Council Reference: DA09/0466
Your Reference: MP08/0234

22 October 2009

RISE” Concept Plan and State Significant Site Application comprising residential, retirement living, retail, commercial, school and open space precincts (MP08_0234) at Lot 1 DP 595529, Lot 1 DP 1033810, Lot 1 DP 1033807, Lot 4 DP 822786, Lot 31 DP 850230, Lot 2 DP 86748 and Lot 33 DP 1085109 Marana Street; Lot 31 DP 850230, Conmurra Avenue; Lot 2 DP 555026 147 McAllisters Road, BILAMBIL HEIGHTS.

I refer to your request for Council’s comments in relation to the Bilambil Heights “Rise” State Significant Site Application and associated Concept Plan.

Extract from Concept Plan with Local Area Structure Plan Image:

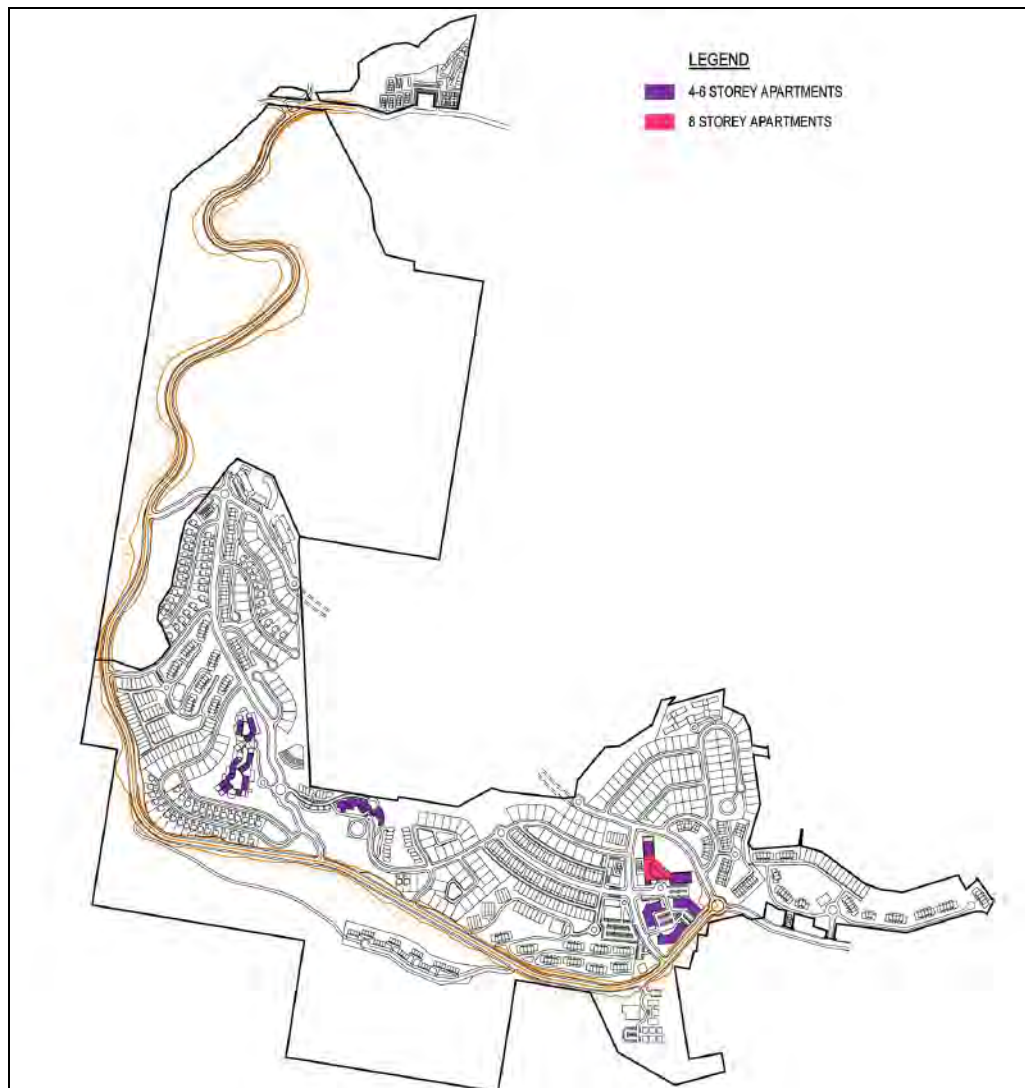
The Local Area Structure Plan was never formally reviewed or reported to Council for any resolution. However, the applicant has indicated that verbal feedback was given by Council staff regarding the comprehensive nature of the Plan.

It is now understood that the Department of Planning has determined that the subject site (Rise) is large enough in its own right to be regarded as a State Significant Site independently of any other adjoining land that forms part of the Bilambil Heights Urban Land Release Area.

Whilst this might be true should the Department approve this concept plan it will have ramifications for Council's future planning of the remainder of the release area.

Council will need to re-consider the Strategic Planning options associated with Bilambil Heights and review whether the Local Area Structure Plan can or should be used as a basis for any future planning. Subsequently it is recommended:

That Council request that a report is brought forward outlining the options available to advance the strategic planning for Bilambil Heights Release Areas (including options in regards to the status of the Local Area Structure Plan prepared on behalf of the "Rise" development)

Figure 2 - Approximate outline of FNC Regional Strategy area relating to the subject site:

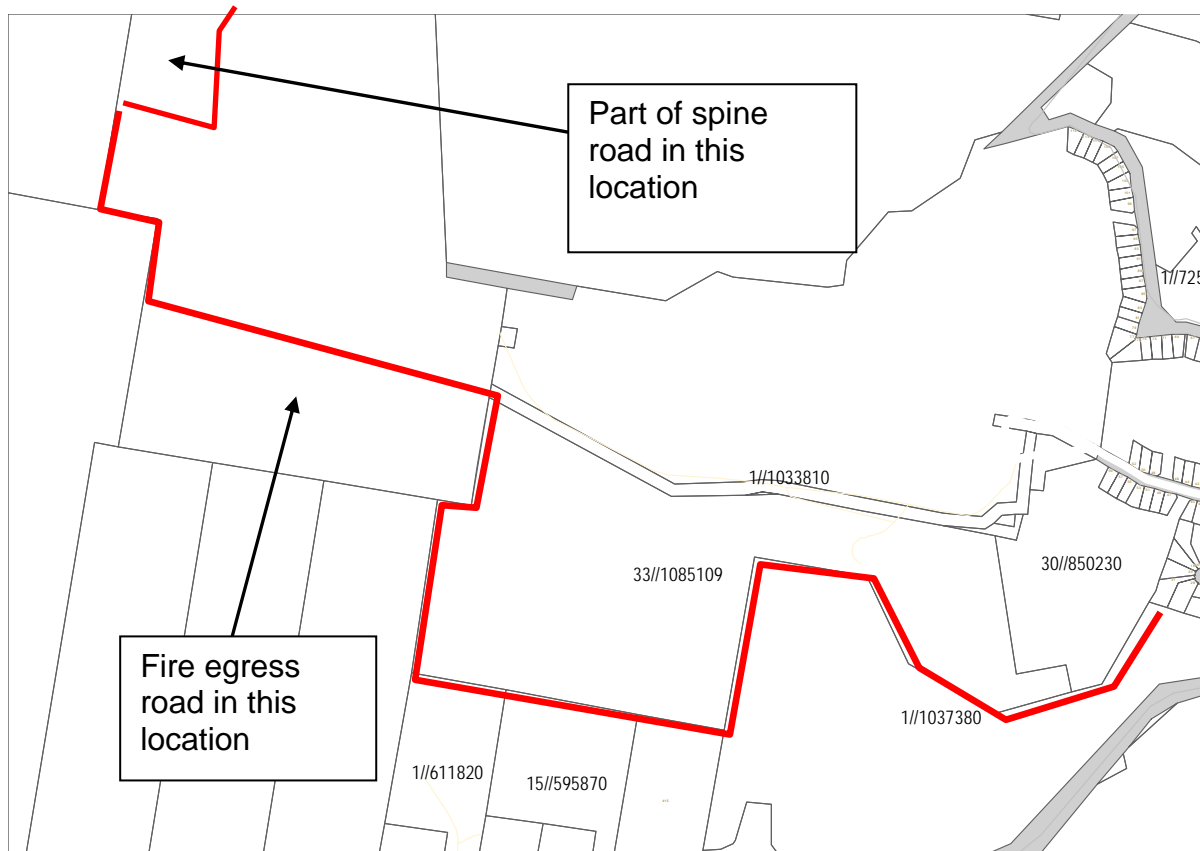
In its proposed location, the western most portion of the spine road appears to be outside of the Far North Coast Regional Strategy area (see Figure 1). The proposed fire egress road to the west of Precinct J is similarly outside any area intended within the strategy for development. Thus it could be argued that the biodiversity value of the site is of sufficient value to limit the extent of the Far North Coast Regional Strategy urban footprint.

A reduced impact arising from Precinct J would be gained were this road able to be removed, but the preferred option to ensure continued long-term viability of this remnant is to remove proposed Precinct J from the remnant area.

- Relocate the spine road and associated development away from the rainforest vegetation and undertake restoration of these section of the site, or
- Remove Precinct J, restore the habitat values within this proposed precinct area and protect the then reasonably large and contiguous area of rainforest remnant in perpetuity as the only available suitable area to offset impacts arising from other parts of the site such as the Spine Road.

The Statement of Commitments should reflect a commitment to remove Precinct J from the proposal and rehabilitate and protect the entire southern remnant.

Figure 2: Location of threatened flora species damaged in 2006, indicated in red.

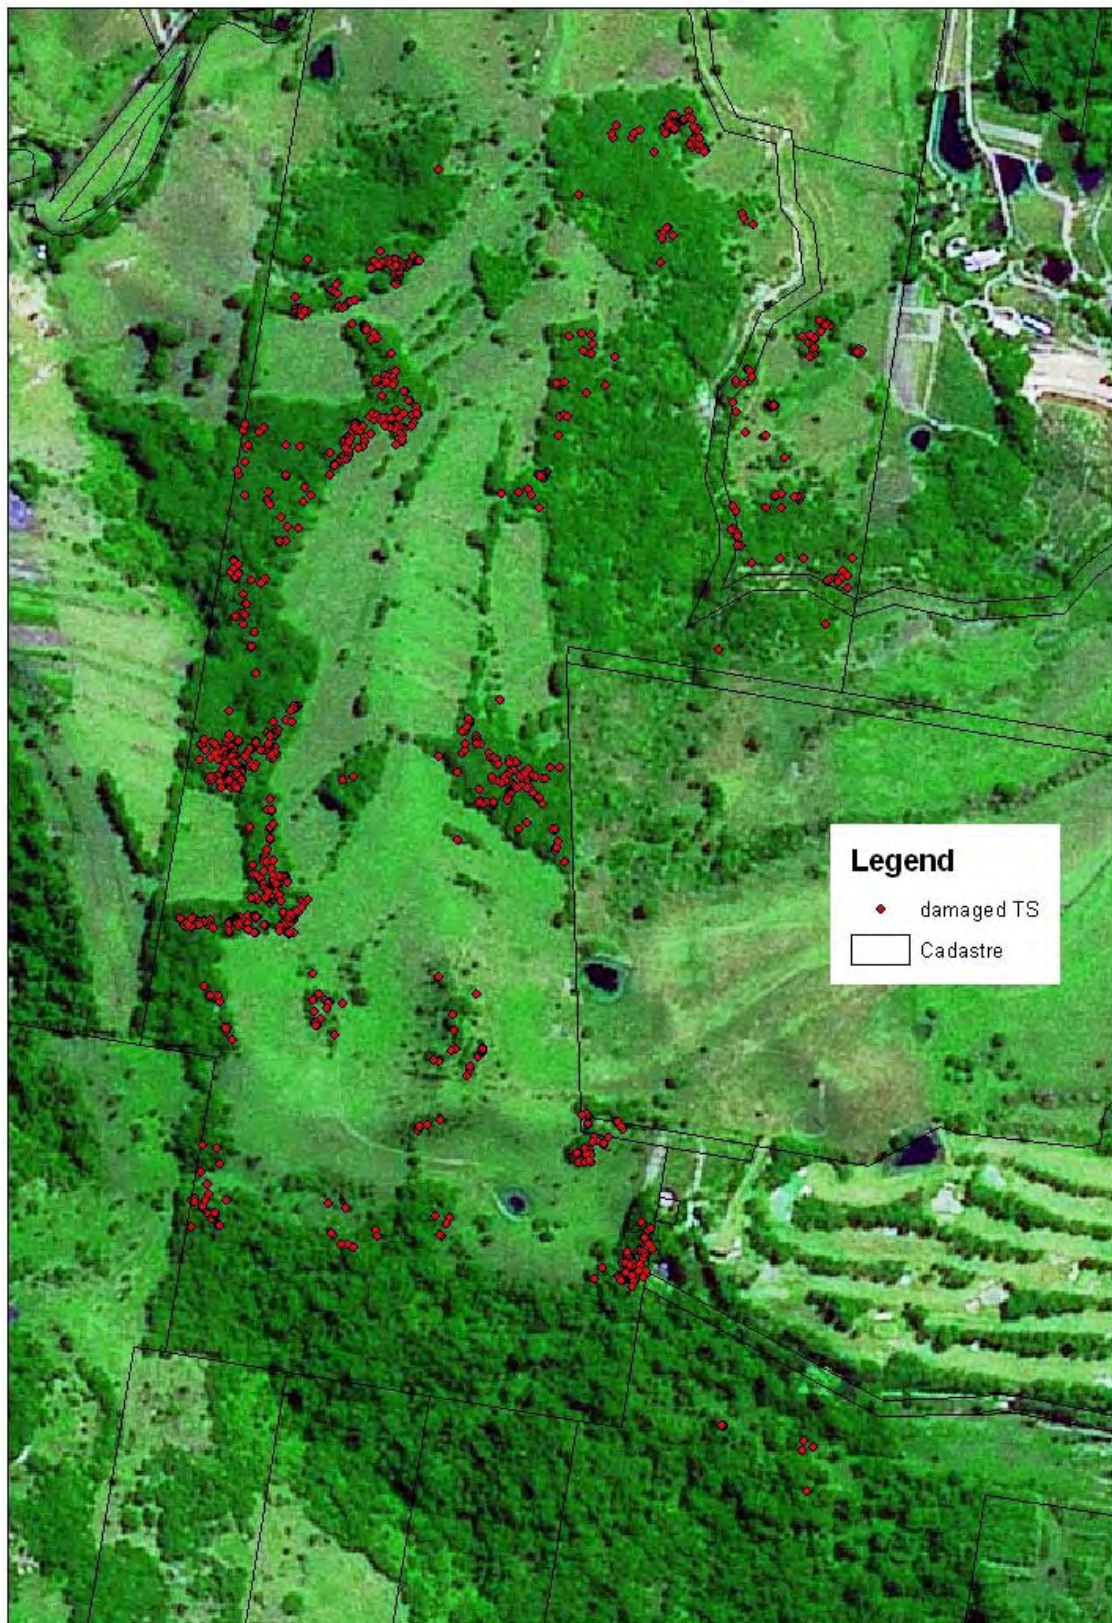
The site is subject to a Land and Environment Court case for which a judgement is yet to be handed down (*DECC vs Rawson*) relating to the death of numerous threatened rainforest plant species. The defendant contractor has pleaded guilty to the removal of threatened flora species numbering in the hundreds while DECCW have estimated damage to more than 1,200 plants (Beaumont (DECCW) pers. comm., 2009).

The Department of Planning has determined that the Concept Plan may be considered despite the absence of judgement in this case. However, because illegal removal has been established through a guilty plea and potential may exist for a restoration order over the site under the Native Vegetation Act, it is considered that approval of a Concept Plan prior to issue of a judgement in this matter may be pre-emptive.

Council staff have been advised that there are still remaining threatened species on the property and a proportion of the previously damaged plants are re-shooting, DECCW is of the opinion that all of the areas where threatened species were damaged are still considered to be threatened species habitat for the purposes of determining the impact and significance of the proposed development (Waern 2009)
